Determination 2021/003

The refusal to issue a code compliance certificate for 20-year-old additions and alterations to a 50-year-old house at 103 Te Hono Street, Tauranga

Figure 1: Site plan sketch

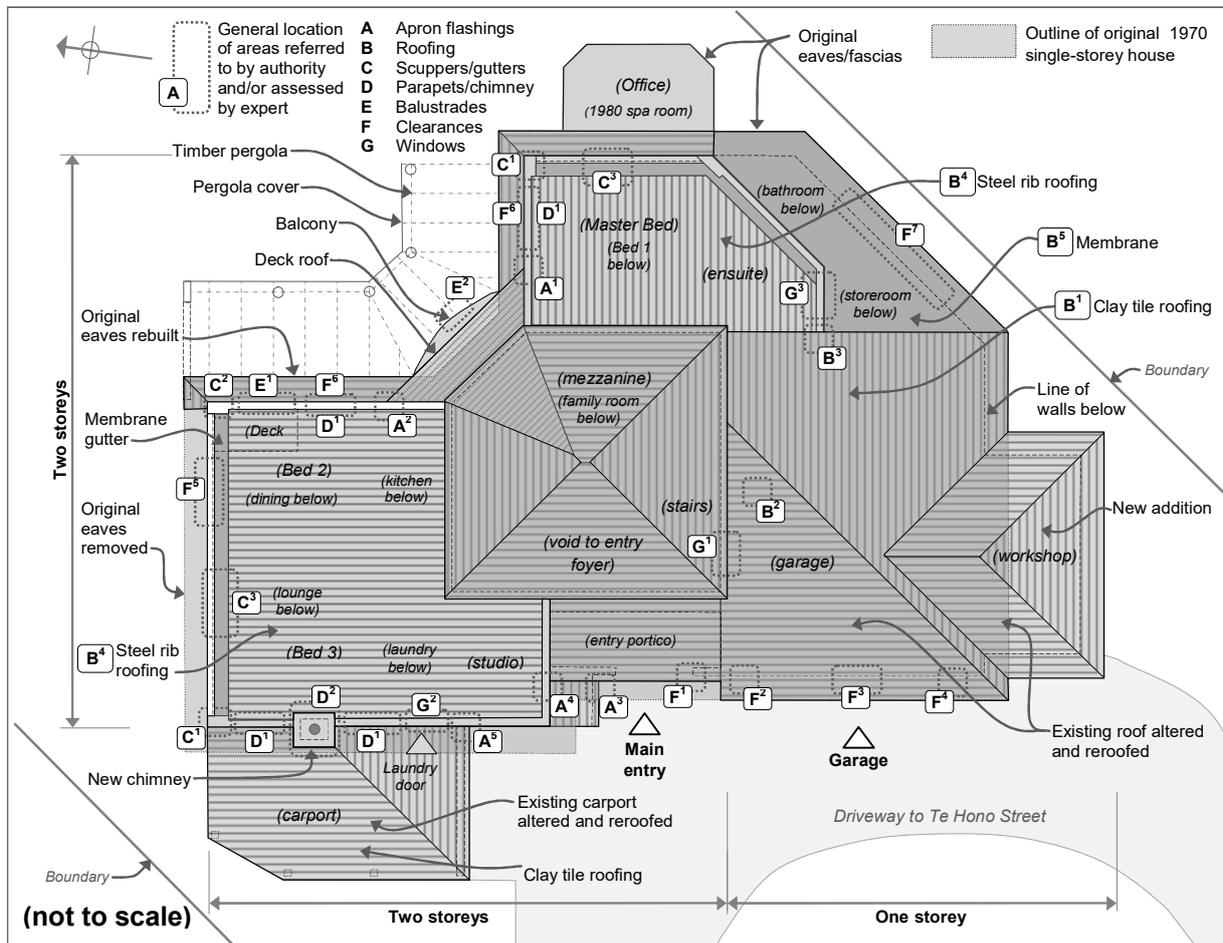
1. Investigation required of all roof areas and critical cladding junctions (Clause E2 [External moisture]) including but not limited to:
 - Ground heights to front entrance area (Areas F)
 - Barge/wall junctions (Areas A)
 - Parapets and roof – specifically outlets and overflows to roof area ... (Areas C and D)
 - Several areas of the bottom plate to brick veneer on the lower level are required to be testing (sic) to confirm supporting structure
2. Seal sanitary fixtures to wall (Clause E3)
3. Door off ensuite to remain locked with key removed or restricted to 100mm opening due to safety from fall issue off membrane roof. (Clause F4 [Safety from falling])
4. Window restrictors required where sill height is less than 760mm (Clause F4)
5. Extraction vent of internal ensuite [Bedroom 2] is not working, this is a requirement due to the lack of natural ventilation (Clause G4).

- junctions of butyl rubber apron flashings with EIFS plaster appeared reasonably well sealed, with the ends directing water away from cladding
 - a low 9% invasive moisture reading was taken in the master bedroom north window lintel, with timber drill shavings appearing to be in good condition (Area A¹)

- there are no internal signs of moisture penetration into the north wall of the master bedroom
 - at the other end of the deck roof, the end of the apron flashing is similar, with the junction reasonably well sealed and no internal signs of moisture penetration into the east wall of the corridor to Bedroom 2 (Area A²).

6.7 There is evidence that the moisture ingress through the clay tile roof on the south garage resulted in several areas of severely decayed roof framing (Areas B² and B³). I am therefore not satisfied that the roof framing in the south garage complies with Clause B2 insofar as it applies to Clause B1 of the Building Code.

- the 650mm height of the clad east balustrade to the recessed deck (Area E¹)
- the lack of window restrictors to studio west window (Area G²).

- 7.1 In accordance with section 188 of the Building Act 2004, I hereby determine that, as there are building elements that do not comply with the Building Code that was in force at the time the building consent was issued, the authority was correct to refuse to issue a code compliance certificate for the building work. Accordingly, I confirm that decision.

Figure 2: Roof parapets⁸

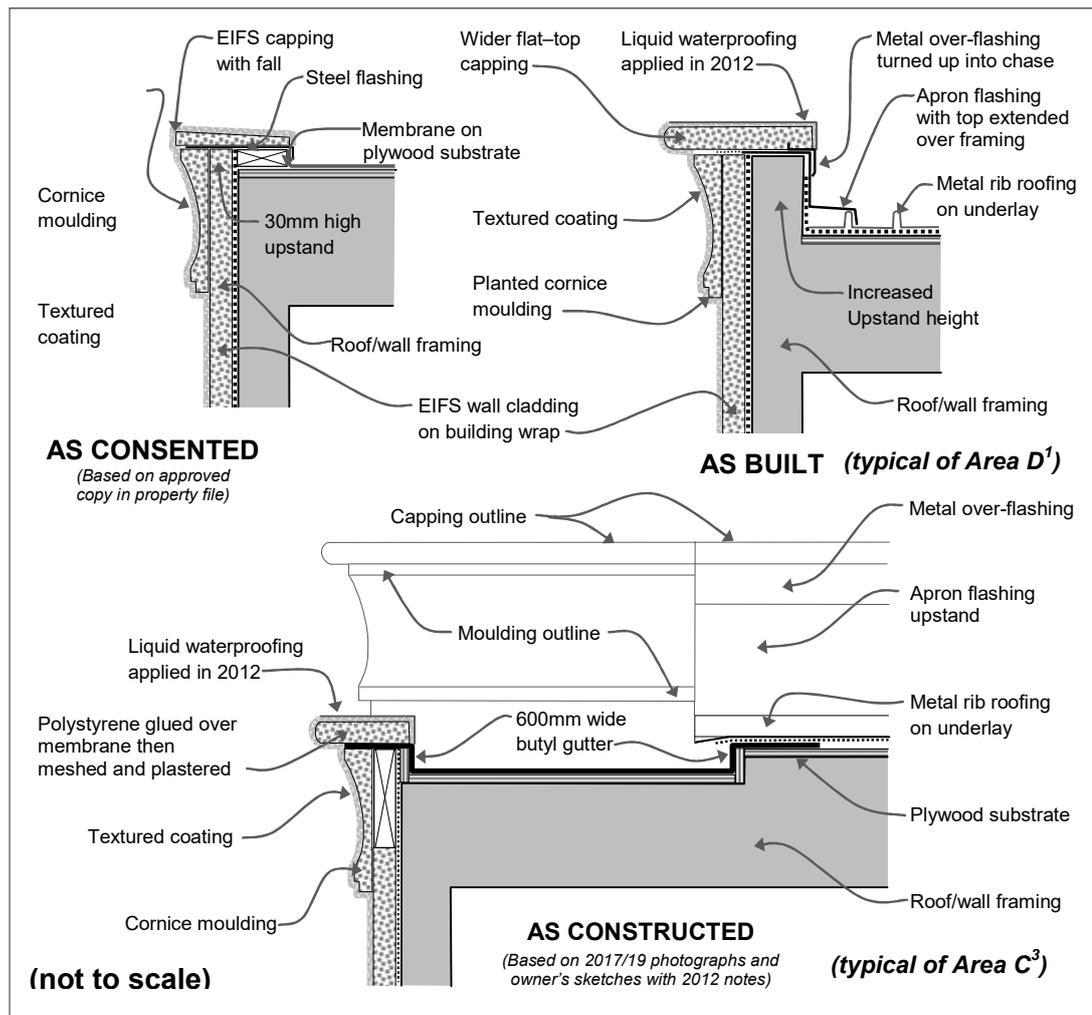
- 2.10 The consent drawings showed the upper bedroom roofs as butyl membrane on plywood substrate, with 30mm high parapet upstands as shown in Figure 2. The membrane was substituted with low-pitched galvanised steel trough roofing during construction. The roofing slopes to membrane-lined internal gutters and adjacent upstands of some 40mm high (Areas C³ in figures 1 and 2), with higher upstands bordering other sides (Areas D¹).

5.9 The EIFS walls extend up to form parapets with flat EIFS ‘cappings’, which project past decorative polystyrene cornices on the exterior as shown in Figure 2. The expert noted regarding the parapets (in summary, with my additional notes added in brackets):

- (From the applicant’s note dated February 2012, it appears a liquid-applied proprietary weatherproofing coating was first used on the top of the polystyrene cappings in 2006)
- all parapets were apparently waterproofed with the same system in 2012, with the coating continued “to the front rounded edge and the inside square edge”
- elevations facing the harbour were repainted in December 2017.
- parapet tops are flat, which increases risks of water penetration at joints
- during an unsuccessful attempt to take a moisture reading in parapet framing, dry timber fragments in good condition were retrieved, which indicated the parapet waterproofing is performing.
